**Re: Defect Information Report – Supplemental Report No. 8
10V-177 School Bus, 10V178 Non School Bus, FL-577
Hydraulic Brake Switches**

July 2011
FL577AB
NHTSA #10V-177 (School Bus)
NHTSA #10V-178 (Non-School Bus)
Transport Canada #10-130
REVISED NOTICE

Subject: Hydraulic Brake Switches

REVISIONS: Approximately 8,300 school buses have been added to the Recall as **FL577B**. Instructions for installing the hydraulic brake switch on adjustable pedals have been added to the Work Instructions. Fixed brake pedals will be inspected and replaced if necessary. Adjustable brake pedals do **not** require an inspection or replacement. The kits and SRTs remain the same.

Fig. 1, Brake Switch Location, Fixed Brake Pedal

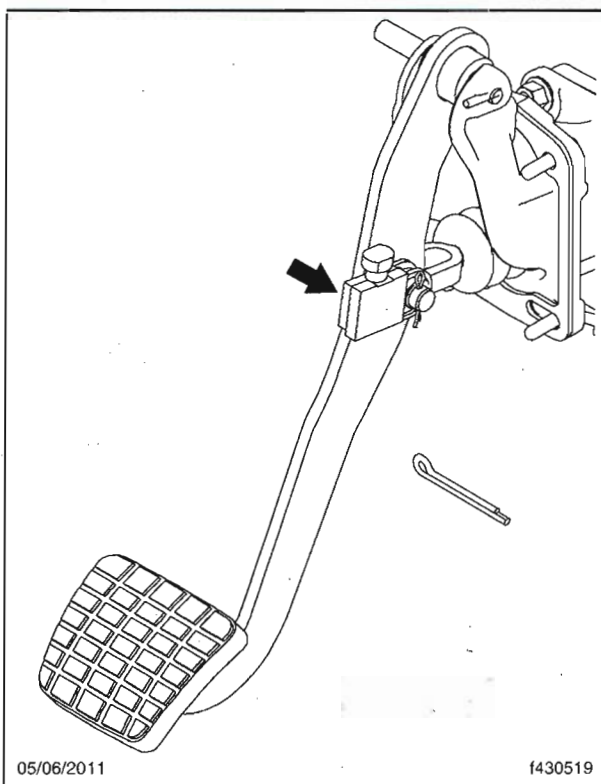
1. Check the base label (Form WAR259) for a completion sticker for FL577 (Form WAR260) indicating this work has been done. On trucks, the base label is usually located on the passenger-side door, about 12 inches (30 cm) below the door latch. On school buses and shuttle buses, the base label is usually located over the driver's window. On motorhomes, the base label is usually located on the front wall, under the dash. If a completion sticker is present, no further work is needed. If there is no completion sticker, go to the next step.
2. Park the vehicle on a level surface, shut down the engine, apply the parking brake, and chock the tires.
3. Determine whether the brake pedal is a fixed or adjustable version. See **Fig. 1** and **Fig. 2**.

1. Locate the brake switch on the brake pedal. See **Fig. 1** for location of the brake light switch on a fixed brake pedal. See **Fig. 2** for the location of the brake light switch on an adjustable brake pedal.
2. Cut the tie strap on the harness leads going to the brake switch, and unplug the switch.
3. Remove the cotter pin, flatwashers, clevis pin, and brake switch and discard all of the parts.
4. Install the new clevis pin, flatwashers, brake switch, and hitch pin from the kit. Make certain one flatwasher is between the pushrod and the brake lever as shown in **Fig. 3**.

4. Inspect the brake pedal for side-to-side play by moving the pedal from left to right. Measure travel at the brake pedal cover.

If the side-to-side play is *over 6 mm*, replace the brake pedal. Go to "Hydraulic Brake Pedal Replacement" in these Work Instructions.

If the side-to-side play is *6 mm or less*, do **not** replace the pedal. Go to the "Hydraulic Brake Light Switch Replacement" in these Work Instructions.

Fig. 3, Brake Switch Installation (fixed pedal shown)

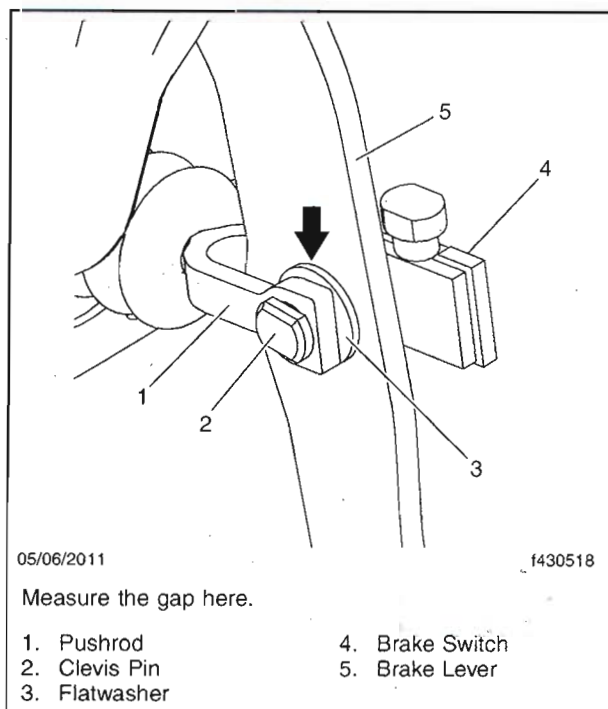
5. Using a feeler gauge, measure the space between the flatwasher and the brake pedal as shown in **Fig. 3**.
If the gap is *less than 1.2 mm*, replace the brake pedal. Go to "Hydraulic Brake Pedal Replacement" in these Work Instructions.
If the gap is *1.2 mm or more*, no further work is needed.
6. Attach the new harness pigtail to the existing harness and the newly installed brake switch. Use tie straps to secure excess wiring away from the throttle pedal.
7. Check for proper brake light operation.
8. Clean a spot on the base label (Form WAR259) and attach a completion sticker for FL577 (Form WAR260) to the base label.

Fig. 4, New Brake Switch Installation (fixed pedal)

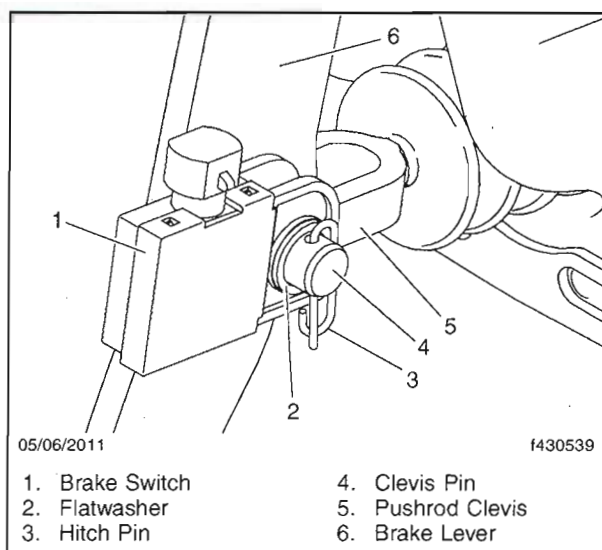
Make certain the other flatwasher is between the brake switch and the hitch pin, and that the hitch pin is installed as shown in **Fig. 4** for fixed brake pedal installations, or **Fig. 5** for adjustable brake pedal installations.

Fig. 6, Removing the Fixed Brake Pedal

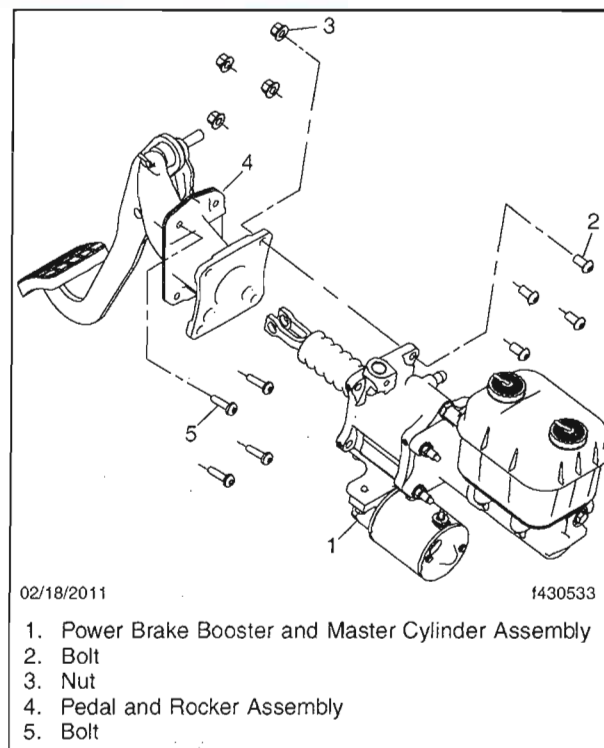
1. Remove the cotter pin from the brake clevis and remove the clevis pin from the brake pedal. See **Fig. 6**.
2. Disconnect the master cylinder from the brake cylinder and support the master cylinder by zip tying it to the engine. Be careful not to bend the hydraulic hard lines.

3. Remove the bolts holding the brake pedal to the frontwall, then pull the brake pedal through the frontwall.
4. Use the existing bolts and install the new brake pedal. Tighten the bolts 10 to 13 lbf·ft (14 to 18 N·m).
